nationalgrid	DISTRIBUTION PLANNING DOCUMENT	Doc. RI-26012283
	Interconnection Study	Page 1 of 41
	Complex Generating Facility – RIPUC 2180	Version 1.0 7/15/20
	EXETER RENEWABLES 1 LLC 10,000kW AC, SOLAR 89 TEN-ROD RD EXETER, RI	Final

System Impact Study for Distributed Generation Interconnection to National Grid’s 34.5kV System

DG WR: RI-26012283
Applicant: EXETER RENEWABLES 1 LLC
Address: 89 TEN-ROD RD
City: EXETER
DG kW/kVA: 10,000 kW and 10,000 kVA
DG Type: SOLAR
Feeder: TBD

Figure B- 1: PCC Configuration

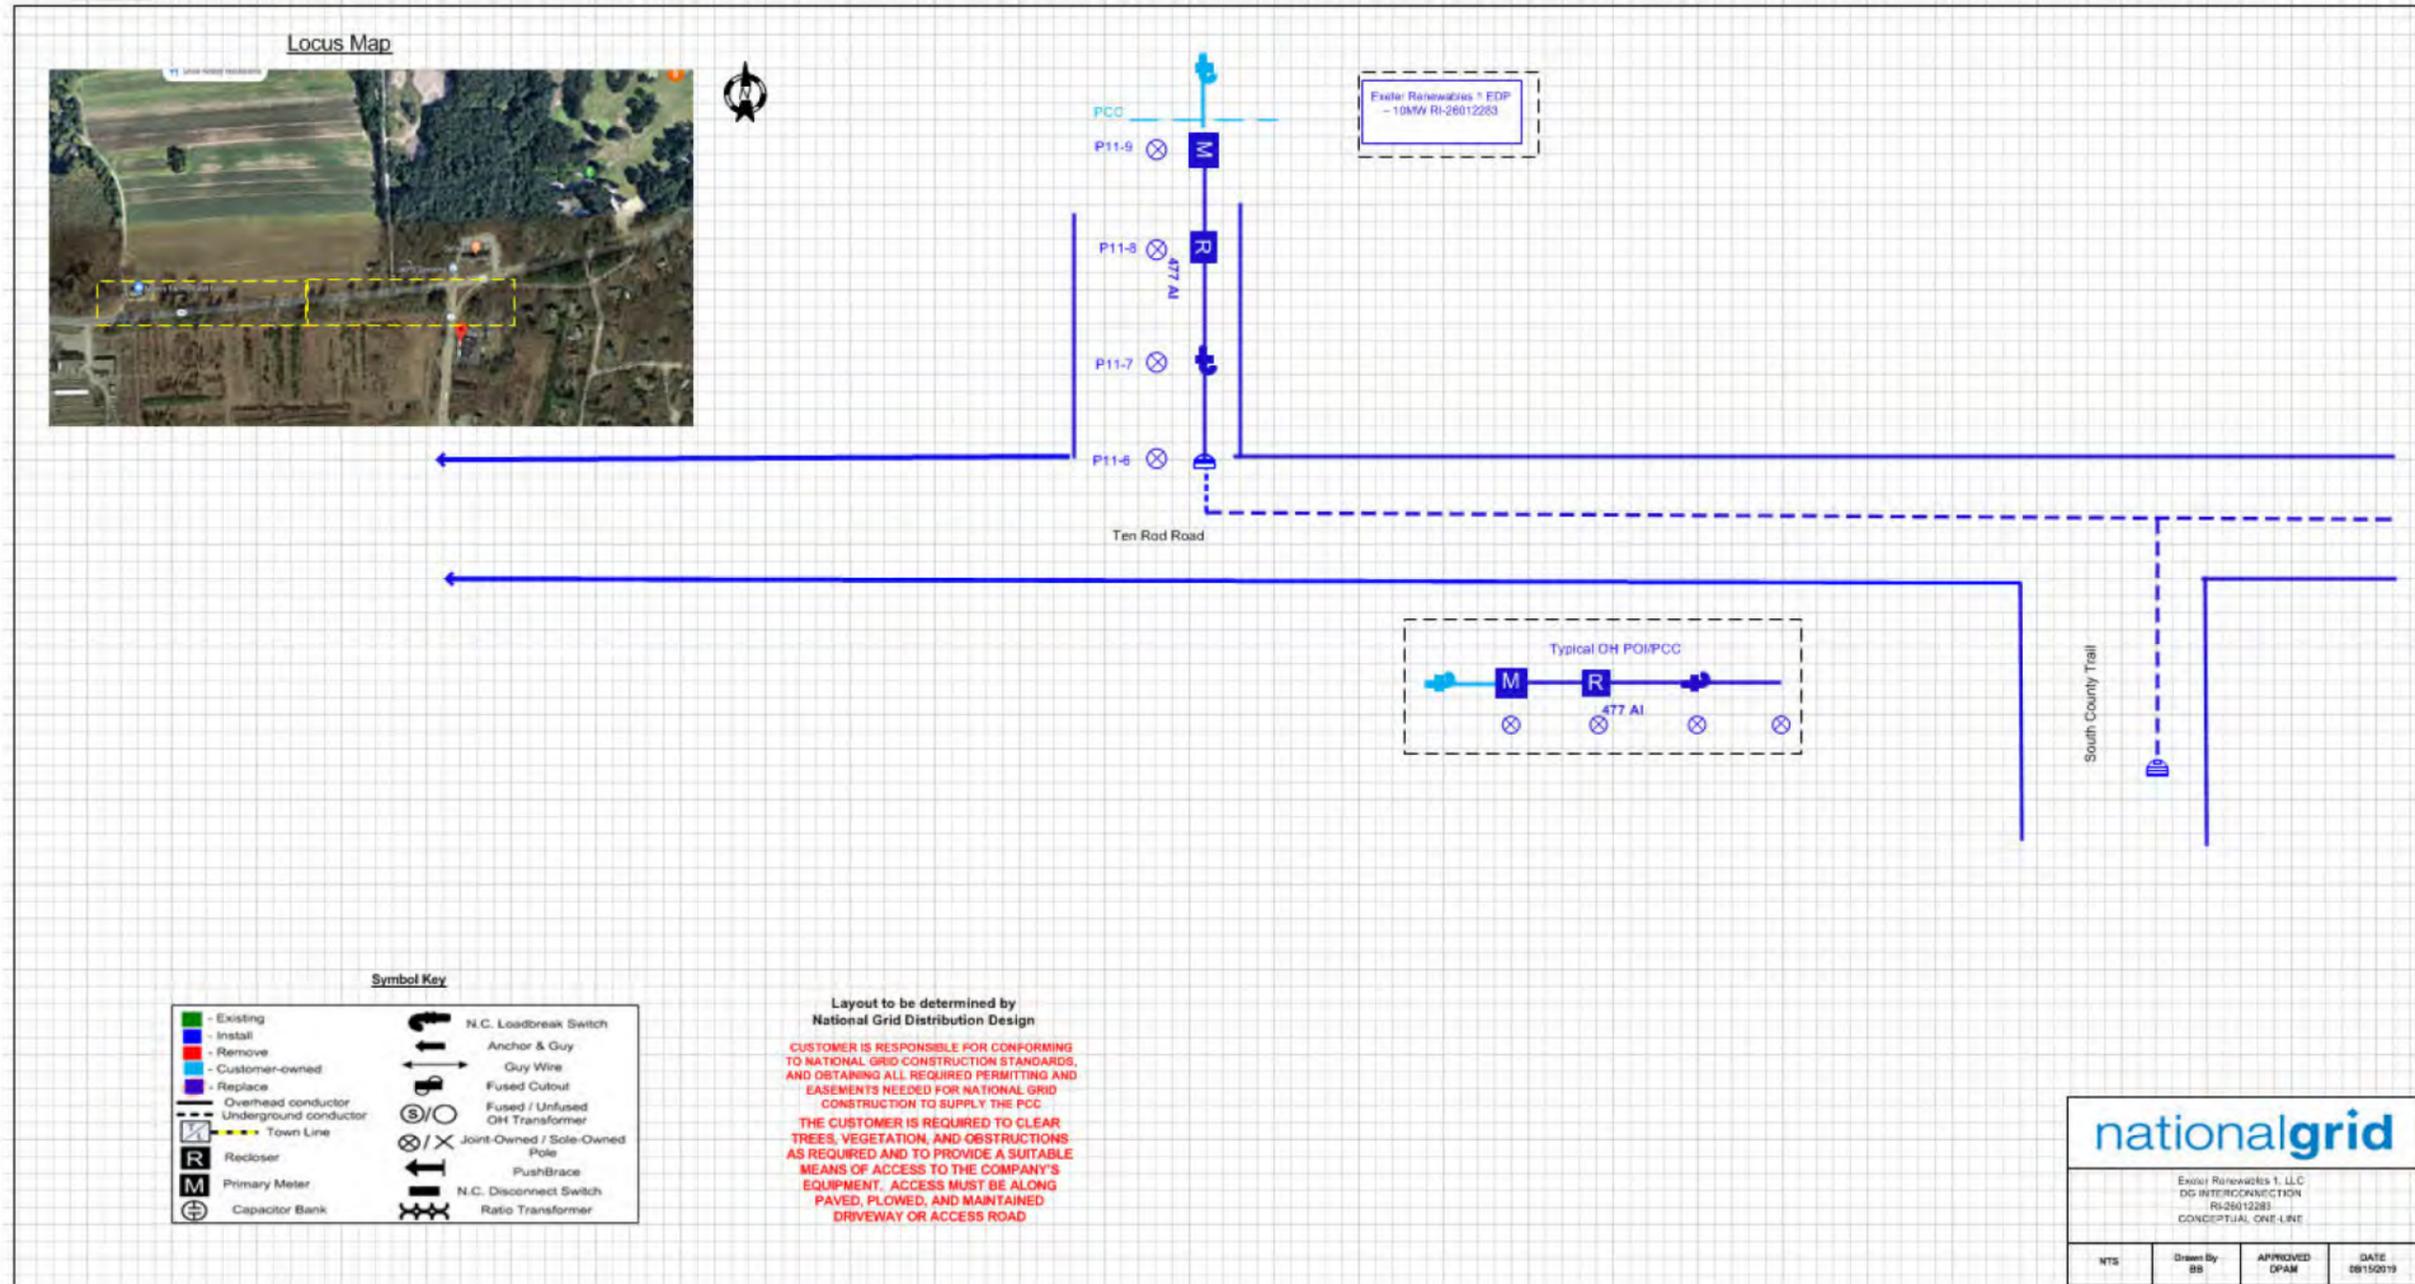
1. Install 7,200 circuit feet of two (2) sets of underground 3-1/C 1000 SCU EPR cable from P9121 in the right-of-way outside Lafayette Substation to existing Pole #5 South County Trail. Customer responsible for installation of Man hole and Duct civil work. (Section 2.2).
2. Install 2,000 circuit feet of one (1) set of underground 3-1/C 1000 SCU EPR cable from manhole located at the intersection of Ten Rod rd and South County trail to riser pole 11-6. Customer responsible for installation of Man hole and Duct civil work. (Section 2).
3. Install a recloser on proposed Pole #11-7 (Figure B-1).
4. Install a three-phase disconnect switch on proposed Pole #11-8(Figure B-1).
5. Install a primary meter on proposed Pole #11-9 (Figure B-1)
